**Subject: PCN# 03A-13 Notification of Intent to Utilize an Alternate Qualified Assembly / Test Site and Alternate Qualified Material Sets for Select Lattice Products**

**“2” in the fifth position of Datecode indicates Cu-wire material set from ASET**

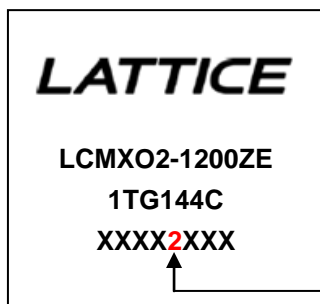
Devices with Cu-wire material sets manufactured at ASET can be identified by a numeric value (“2”) in the fifth position of the datecode marked on the topside of the devices. This datecode is also marked on the label on the outside of the inventory box as well as on the anti-static, moisture barrier bag within. See device topside marking example below:
